City of Biddeford

Planning Board

5.A. 2020.41 Resubmittal from Planning Board of January 20, 2021. Shoreland Zoning Determination of Greatest Practical Extent for Linda Nash and Steve Rosenfield at 1 Sea Spray Drive (Tax Map 67, Lot 26-1) in the Coastal Residential and Limited Residential (Shoreland Zone)

PLANNING
BOARD REPORT

SP1.2

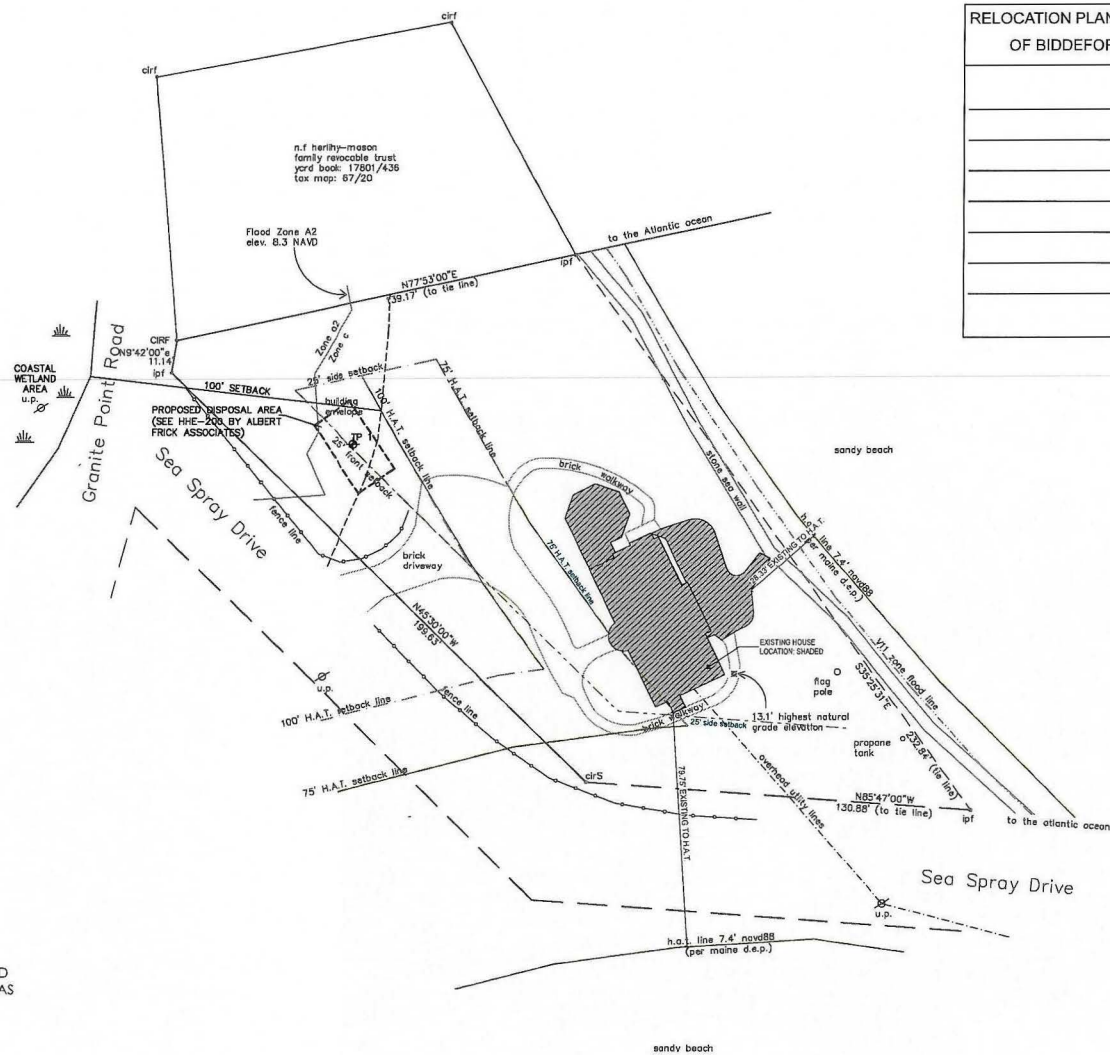
When considering the Site Plan submitted it appears the new location is not as close as possible to the 25-foot Front Yard Setback. Speaking with the applicant's agent, the applicant is concerned with the logistics (i.e. safe and reasonable maneuvering in and out) to relocating the existing driveway further back. The Board should decide if maintaining the driveway location is reasonable and will not conflict with determining that the structure location conforms to the setback from the protected resource *to the greatest practical extent*. **The applicant has submitted a new plan that incorporates the proposed building footprint and demonstrates locating the new structure as far back from the protected resource as the front 25-foot setback from Sea Spray Drive. Plans have been revised to include the 100-foot setback from the coastal wetland located across Granite Point Road, as the Board requested.**

1. The Site Plan needs an approval signatory block, a recording block, and a plan note that describes the regulatory approval that is being sought. **Plans have been revised.**
2. **The Boundary Survey prepared by Livingston-Hughes (previously submitted) should be referenced on the final plans prepared by Kevin Brown Architecture, as the base information that is, presumably, be utilized.**
3. **The Boundary Survey should also be recorded along with the Planning Board approved plans.**
